PROPOSED TECHNICAL SPECIFICATION CHANGES
REGARDING IMPLEMENTATION OF BWROG OPTION I-D
LONG-TERM SOLUTION FOR THERMAL HYDRAULIC STABILITY

JAMES A. FITZPATRICK NUCLEAR POWER PLANT

Docket No. 50-333

**SAFETY EVALUATION FOR
PROPOSED TECHNICAL SPECIFICATION CHANGES
REGARDING IMPLEMENTATION OF BWROG OPTION I-D
LONG-TERM SOLUTION FOR THERMAL HYDRAULIC STABILITY**

Figure 3.5-1
Thermal Power and Core Flow Limits of
Specifications 3.5.J.1, 3.5.J.2 and 3.5.J.3

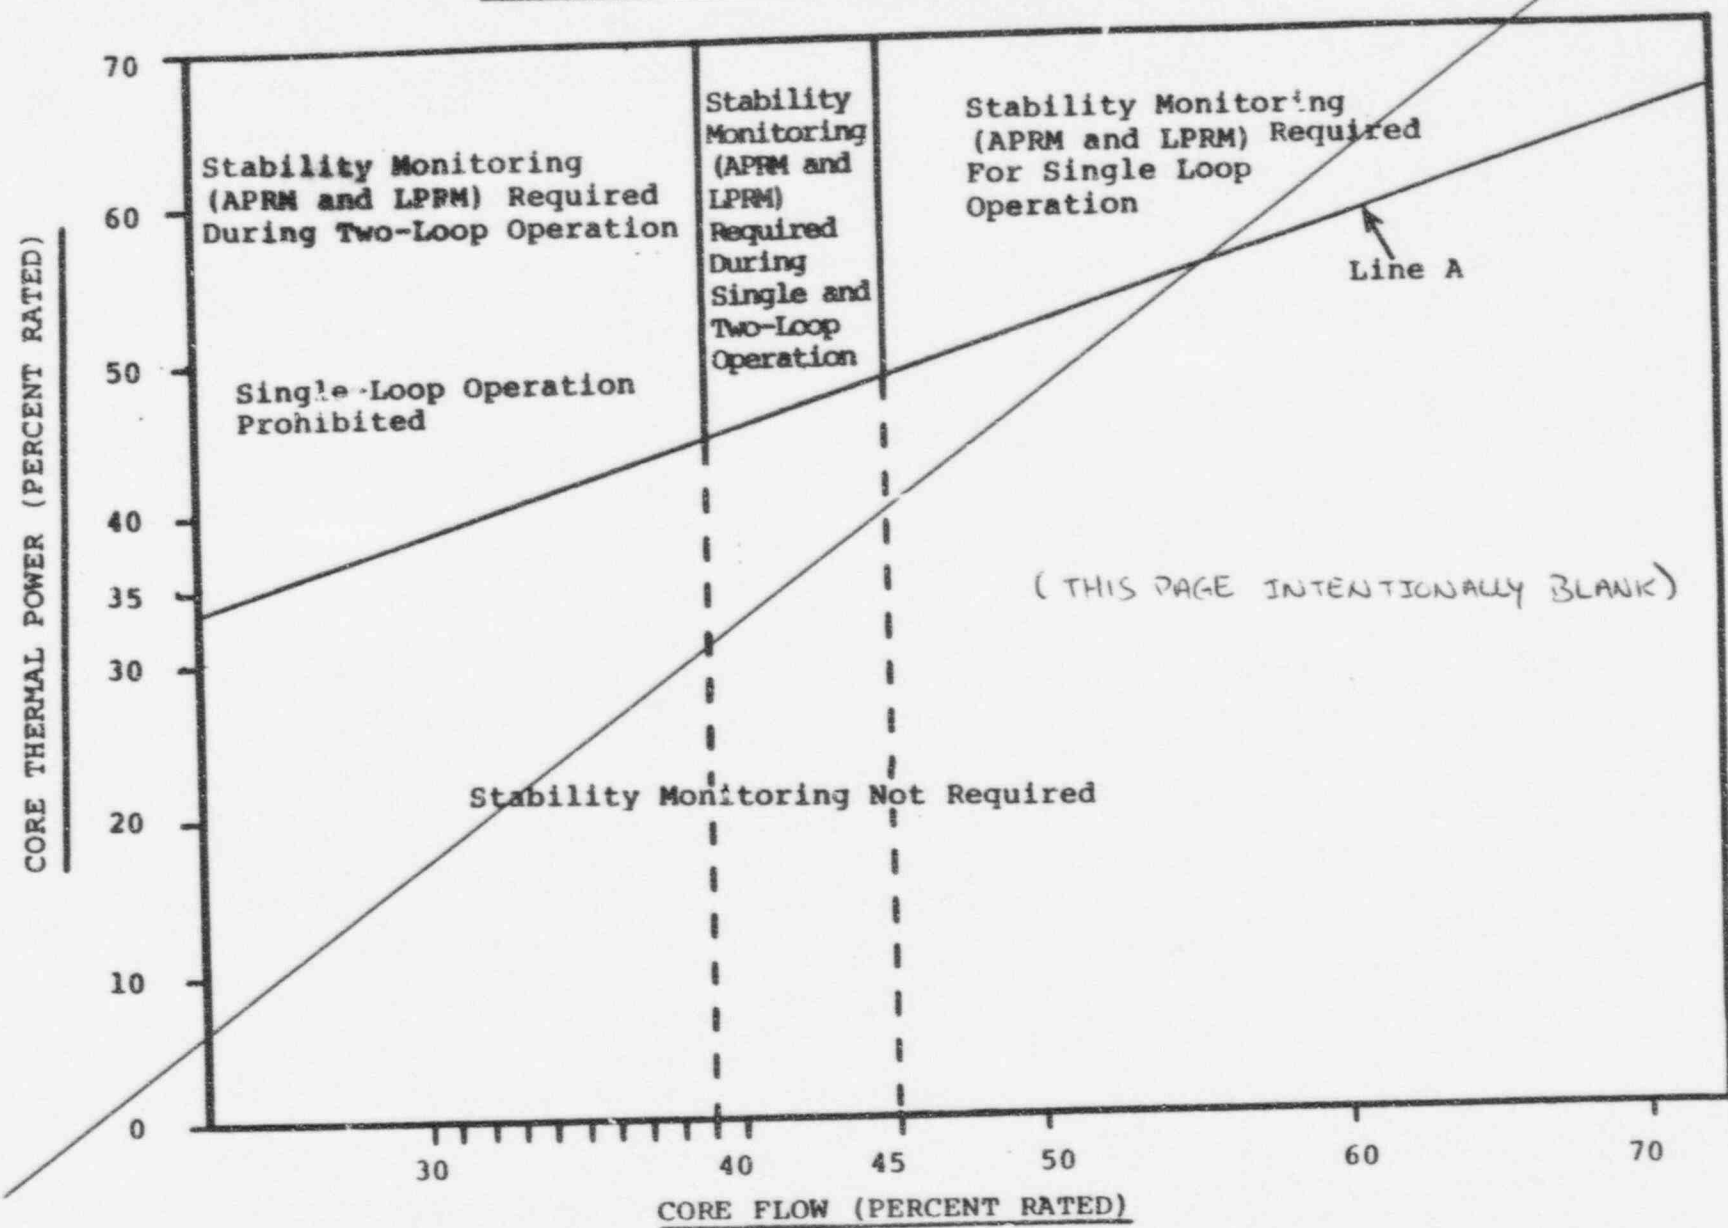
Delete Figure 3.5-1, mark page "(THIS PAGE INTENTIONALLY BLANK)."

The purpose of changes related to replacement of a generic restricted region (Figure 3.5-1, being removed from the Technical Specifications) which may be entered with appropriate monitoring, with a cycle specific exclusion region (to be provided in the COLR) which is not to be entered during normal operation, is to prevent the occurrence of thermal hydraulic oscillations while removing unnecessary operating limitations.

Changes to pages 124a through 124c, 131 and 134 include those which provide increased protection against potential fuel damage as a result of unstable reactor operation. The present Technical Specifications allow operation within a generically defined region of the core power/flow map in which thermal hydraulic instability is thought to be possible, provided the operators utilize enhanced monitoring to detect an instability and provided action is taken to suppress an instability, should it occur. The proposed changes prohibit normal operation within a plant specific power/flow exclusion region in which instabilities are conservatively predicted to occur. If entry is made into the exclusion region as a result of a plant transient, the proposed changes require immediate exit by either increasing reactor water recirculation flow or by inserting control rods. Therefore, the proposed changes reduce the potential of occurrence of thermal hydraulic instabilities.
